REFERENCE	BT_2010_FR20_07_UK
DATE	2010 March 22 nd
SUBJECT	Provisional modification for Engine oil transfer – Heel-rest – Engine loom modification – Pad retaining bolt
PART	Vortex to catch tank pipe, heelrest, engine looms, brake callipers

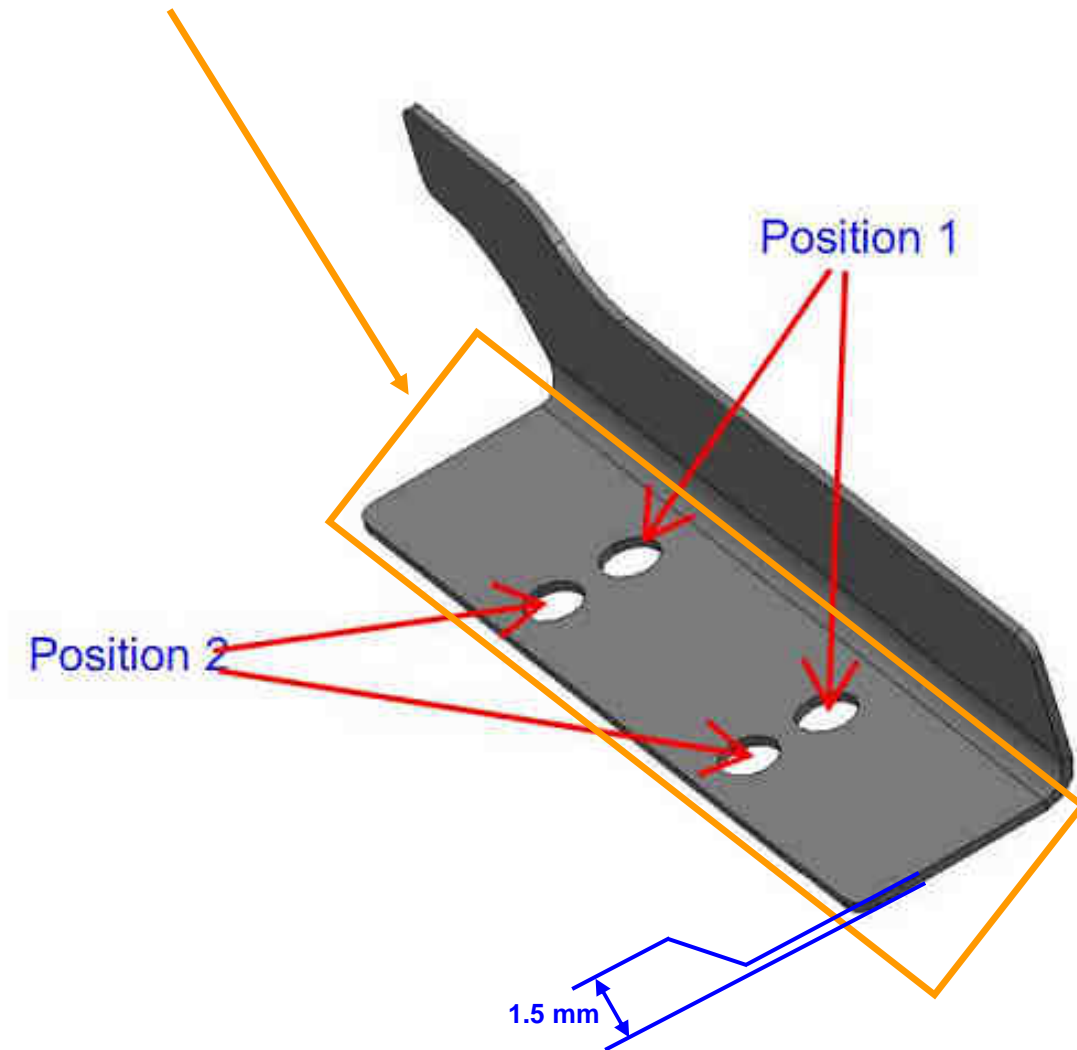
Renault Sport will be able to provide to the more impacted teams a longer pipe to connect the oil tank to the catch tank as shown below:

If the pipe is pinched, please add a metallic collar here

This modification significantly slows the engine oil transfer from the oil tank to the catch tank that a majority of cars suffered in Magny Cours. Renault Sport will come back to you with a definitive solution before the first WSR meeting in Motorland.

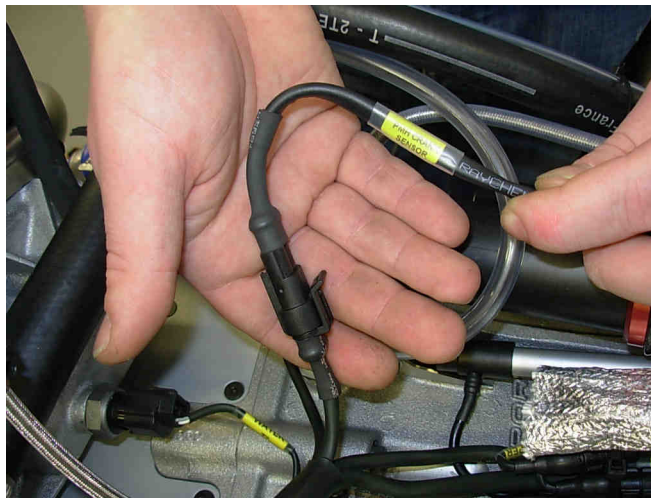
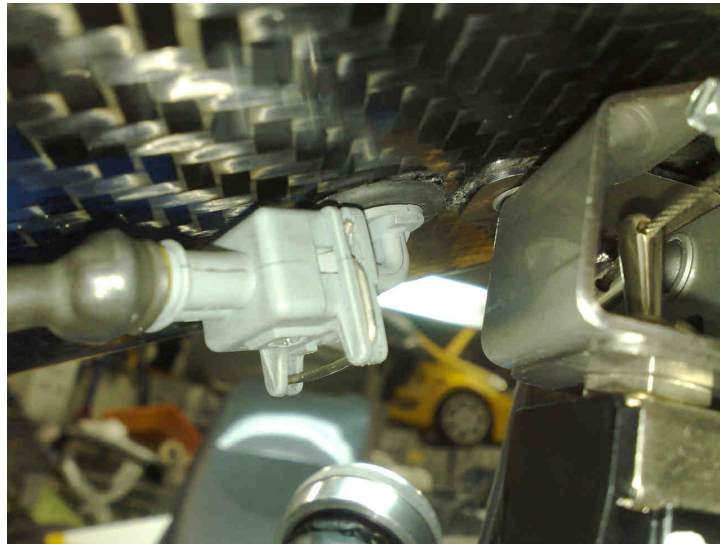
The wires of the air temperature and crankshaft sensors will be updated with a better quality wire as shown on the pictures below:

Please respect this mounting

This metallic collar is mandatory and considered as a C category part (available at the Renault Sport spare parts truck in Motorland from Tuesday afternoon). The head cylinder screw must be tightened at 12 N.m.

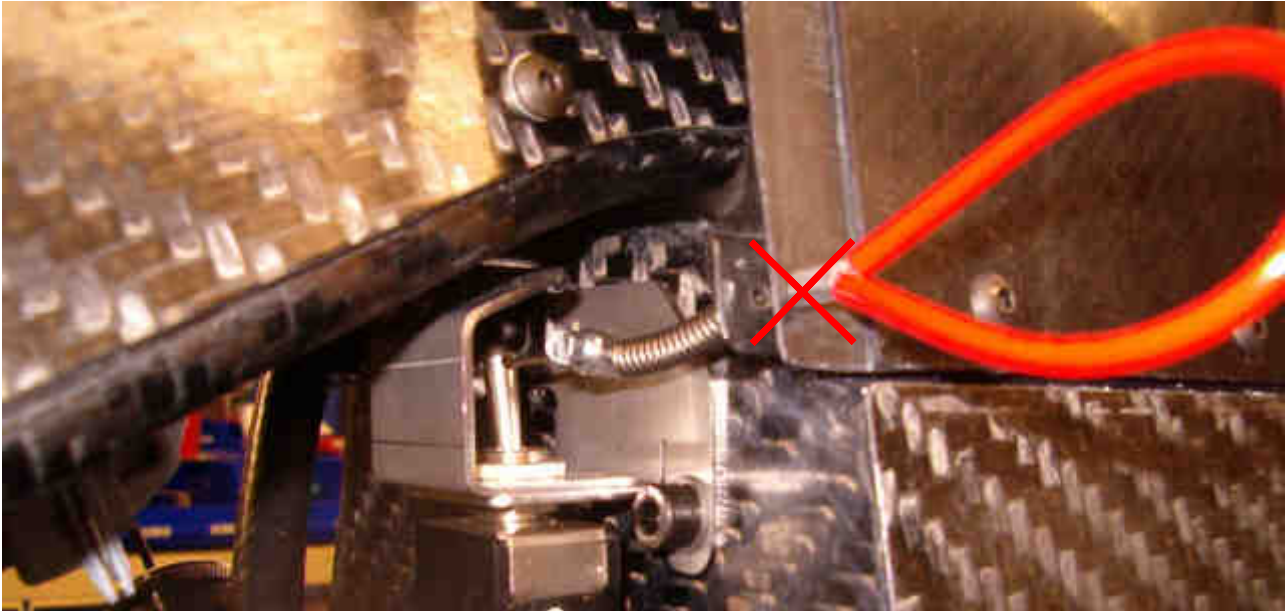
The air temperature sensor is now fitted with a rubber grommet on the airbox. You must remove the aluminium insert and drill the hole at $\varnothing 18\text{mm}$ (Tool available from the Renault Sport technical support). Then put the rubber grommet (available at the Renault Sport spare parts truck from Tuesday afternoon) on the airbox and mount the sensor:

The new crank shaft wire is now connected to the engine loom using a Superseal connector.

A specific crankshaft loom has been created (due to its proximity with the exhaust line) and will be replaceable without replacing the complete engine loom.

NOTE: these modifications can be applied without removing the engine loom from the car.

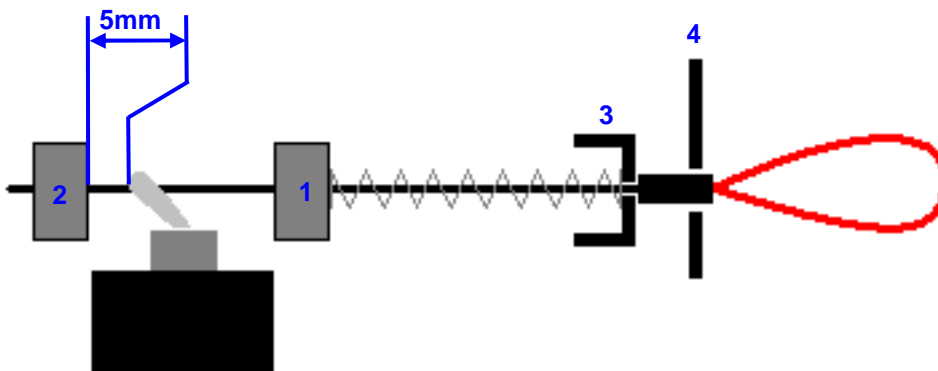
The spring must be enough preloaded between the first cable stop (1) and the roll hoop bracket. There must be a minimal distance of 5 mm between the second cable stop (2) and the switch lever.

The hole in the roll hoop cover must be enlarged to permit the cable loop to stop against the roll-hoop bracket (3) and not against the roll hoop fairing (4) like on the above picture.

It is allowed to trim a little bit the engine cover around the master switch cable. This modification is recommended as the engine cover may pull the cable in some specific cases.
